BERRYVILLE AREA DEVELOPMENT AUTHORITY MEETING AGENDA

Wednesday, March 26, 2025, 1:00pm

SITE DEVELOPMENT PLAN (SP-25-01)

STAFF REPORT – Clarke County Department of Planning

SITE PLAN

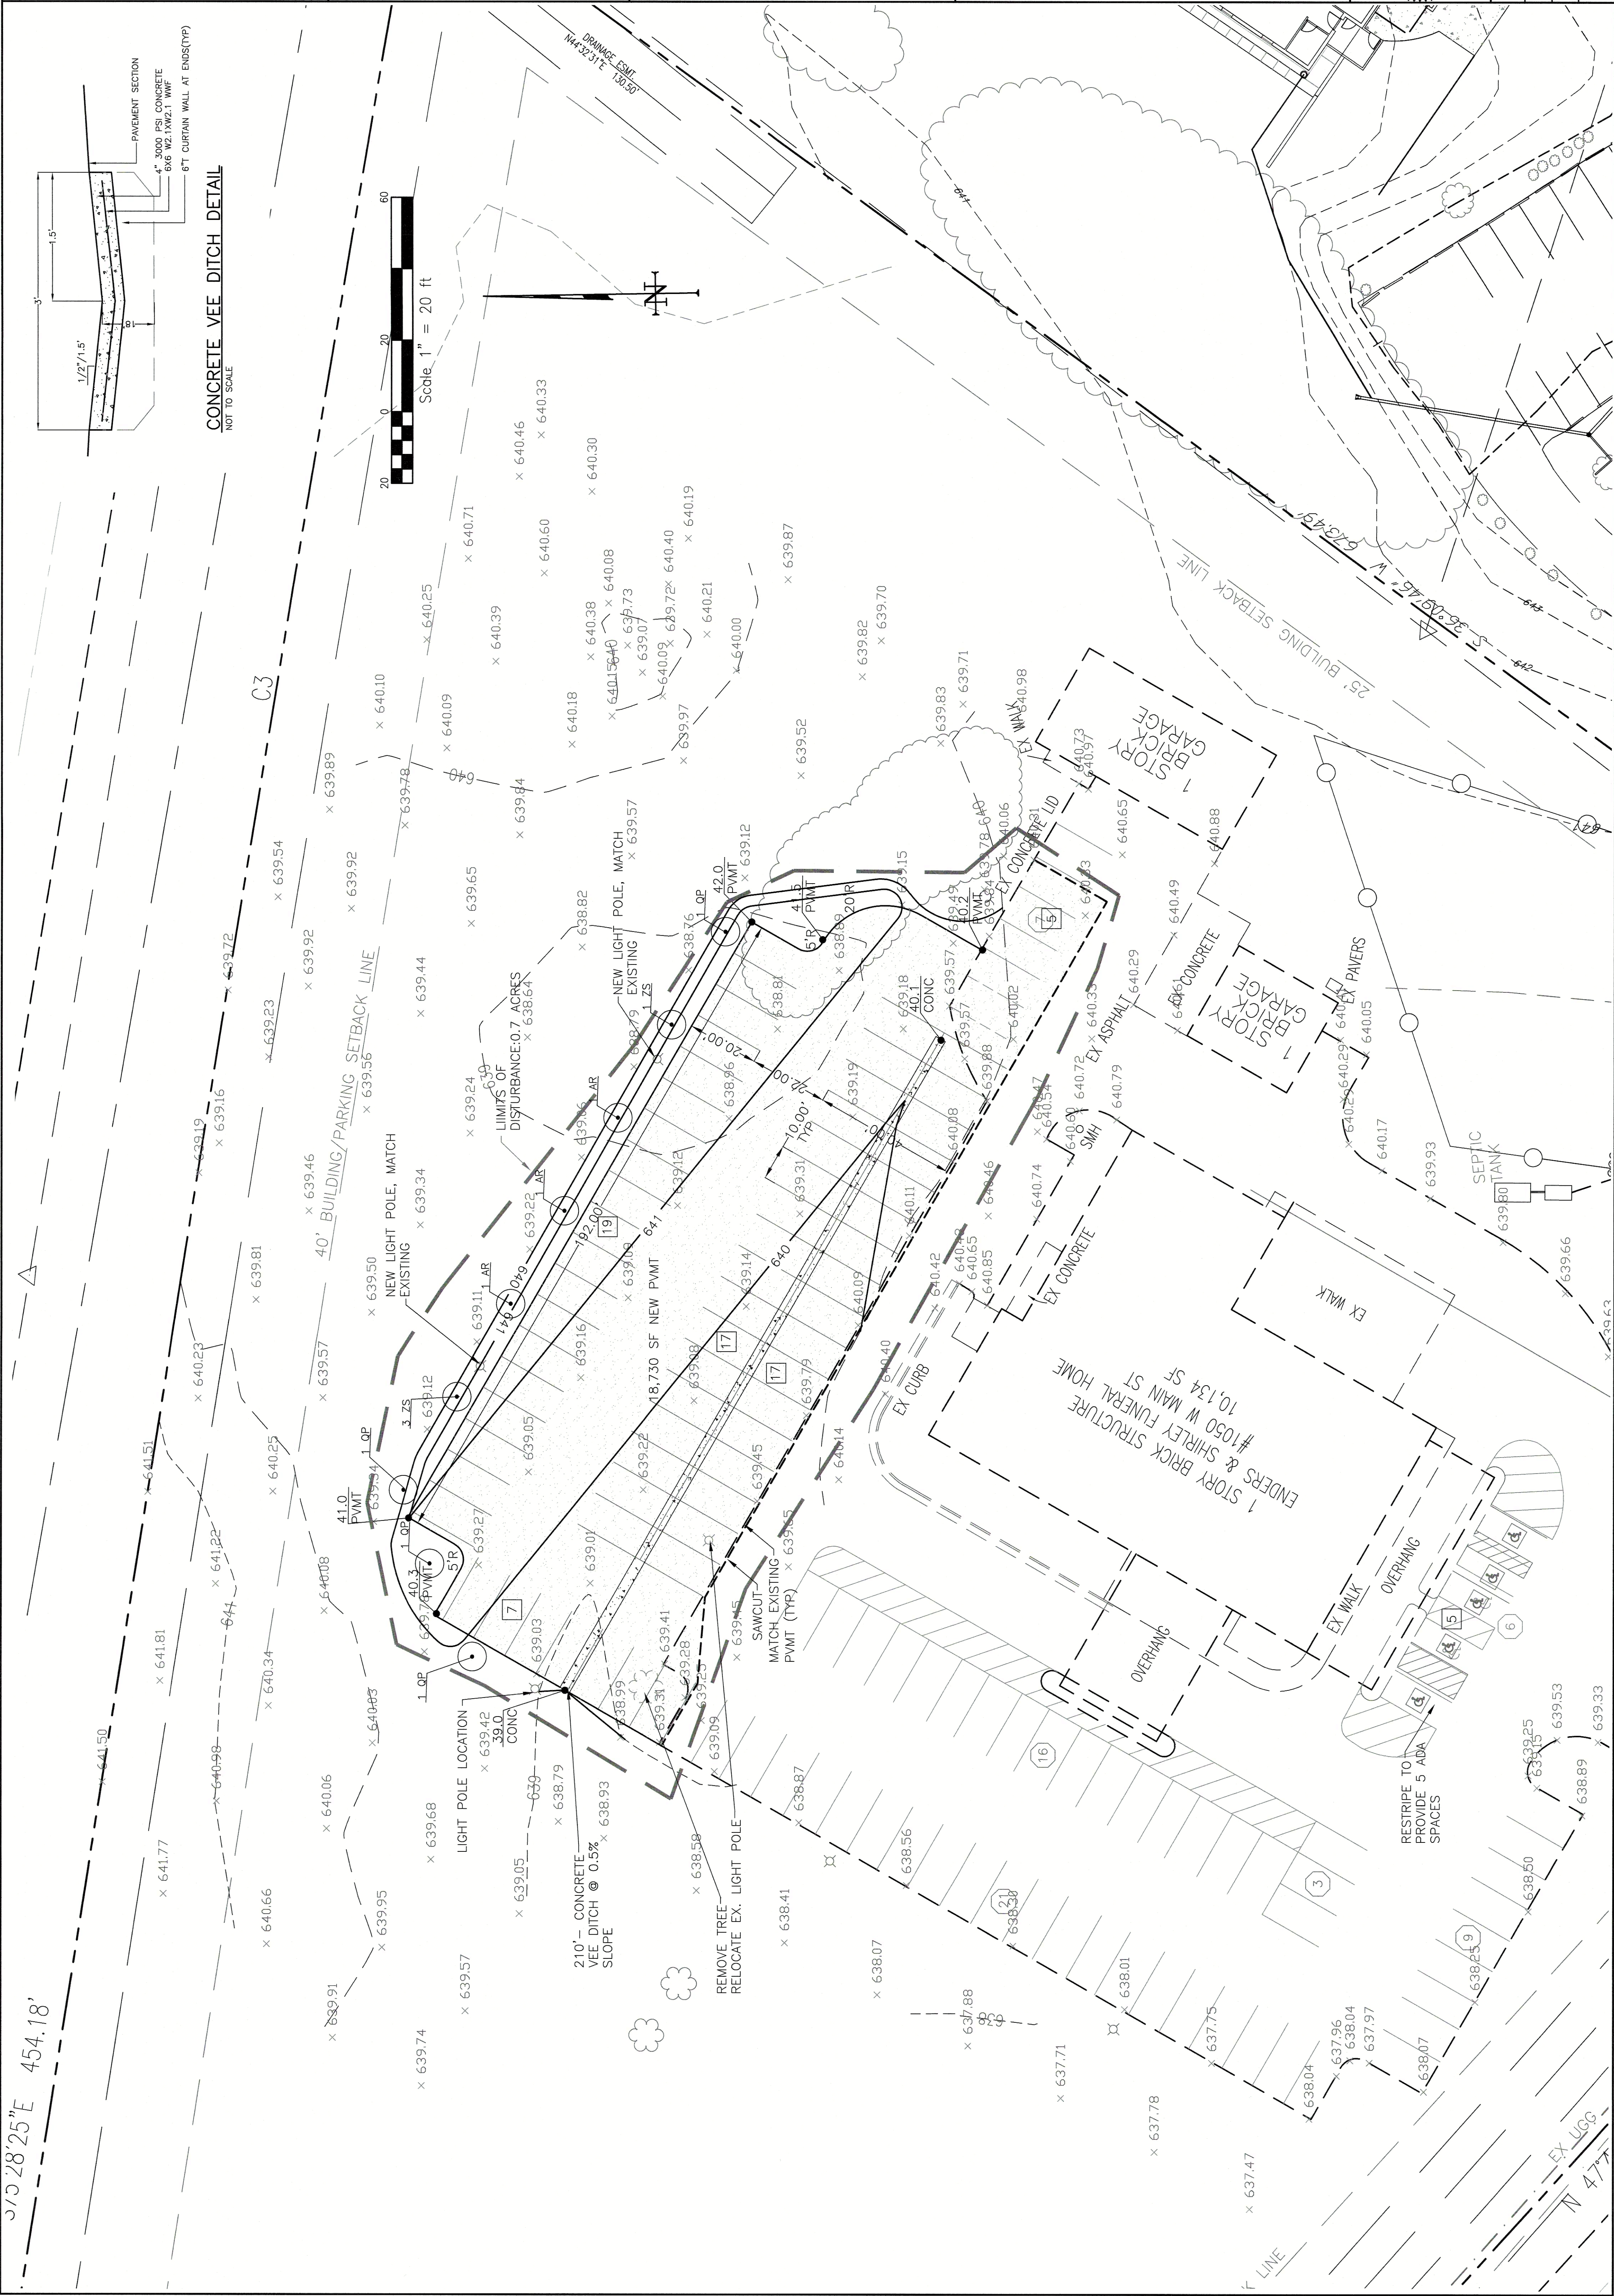
A shallow concrete ditch (VEE ditch) with a .5% slope is shown on the site development plan between the first two parking lot rows. This is being added for stormwater management purposes. A typical detail of this VEE ditch is shown on the site development plan (illustration below).

[3/19/2025] "We issued an operation permit for this septic system on **May 21, 1997** with a design capacity of 664 gallons per day for a funeral home with up to 300 patrons per day and 4 employees. This was issued as a conditional permit. The condition was that permanent water saving fixtures shall be installed in the funeral home including but not limited to low flush toilets. A drip system was installed and the footprint is different from the one shown on the plans for the parking lot. We issued a certification letter for an LPD system in **July 1996** and it looks like Painter Lewis used that DF plans/footprint on their plans for the parking lot expansion. The Drip system is in the same general

We issued an operation permit for this septic system on May 21, 1997 with a design capacity of 664 gallons per day for a funeral home with up to 300 patrons per day and 4 employees. This was issued as a conditional permit. The condition was that permanent water saving fixtures shall be installed in the funeral home including but not limited to low flush toilets. A drip system was installed and the footprint is different from the one shown on the plans for the parking lot. We issued a certification letter for an LPD system in July 1996 and it looks like Painter Lewis used that DF plans/footprint on their plans for the parking lot expansion. The Drip system is in the same general area as what is shown on the plans and it shouldn't impact the parking lot expansion, but I would recommend that they update their drawing to accurately reflect the drip system design and reserve area.

EROSION AND SEDIMENT CONTROL PLAN

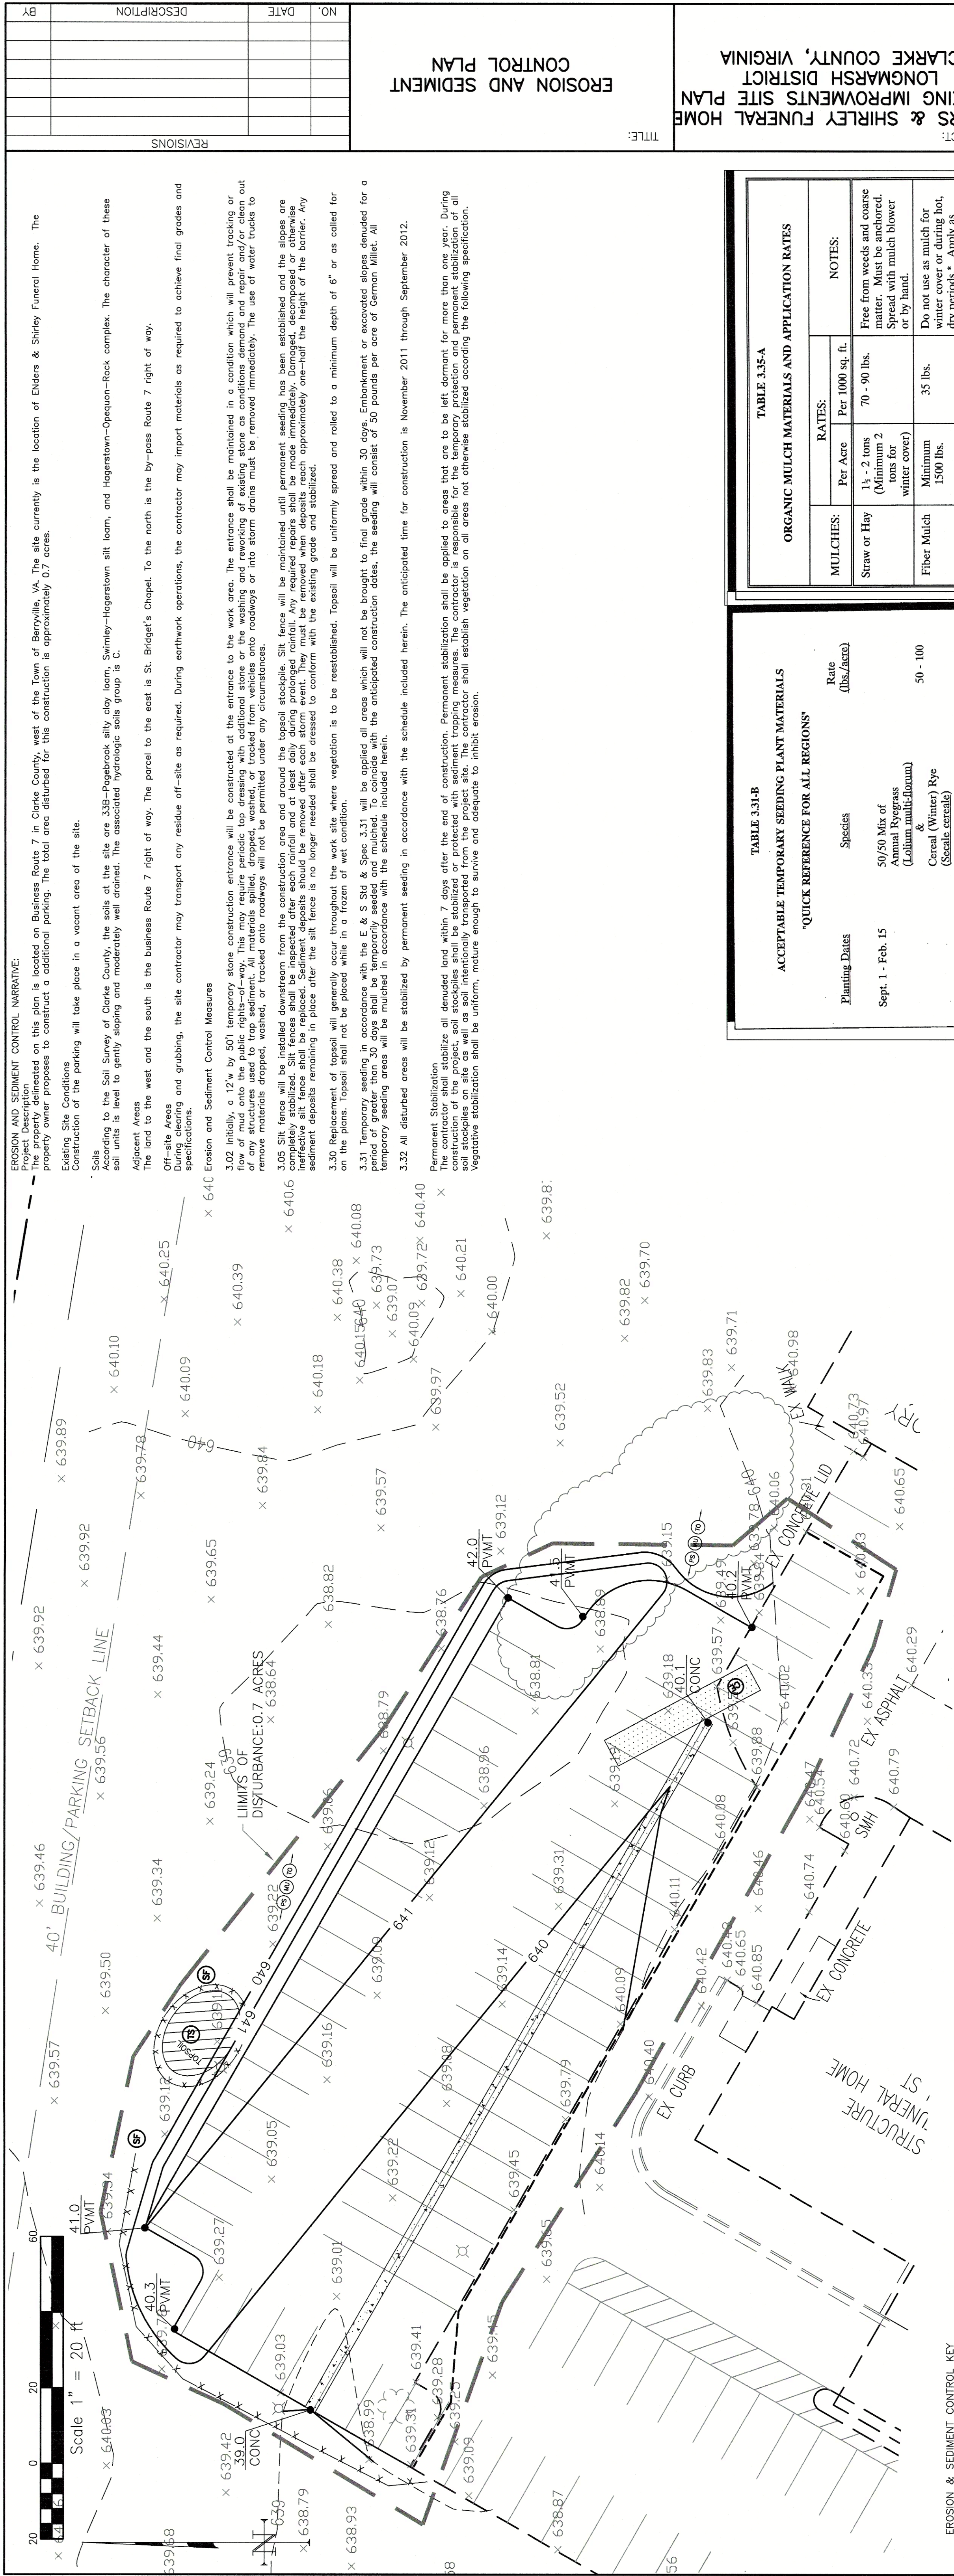
The submitted site development plan includes an erosion and sediment control plan on page 4. This has been submitted to the County's engineering consultant firm for review, but as of the date of this report that review is incomplete (See review comment #2).
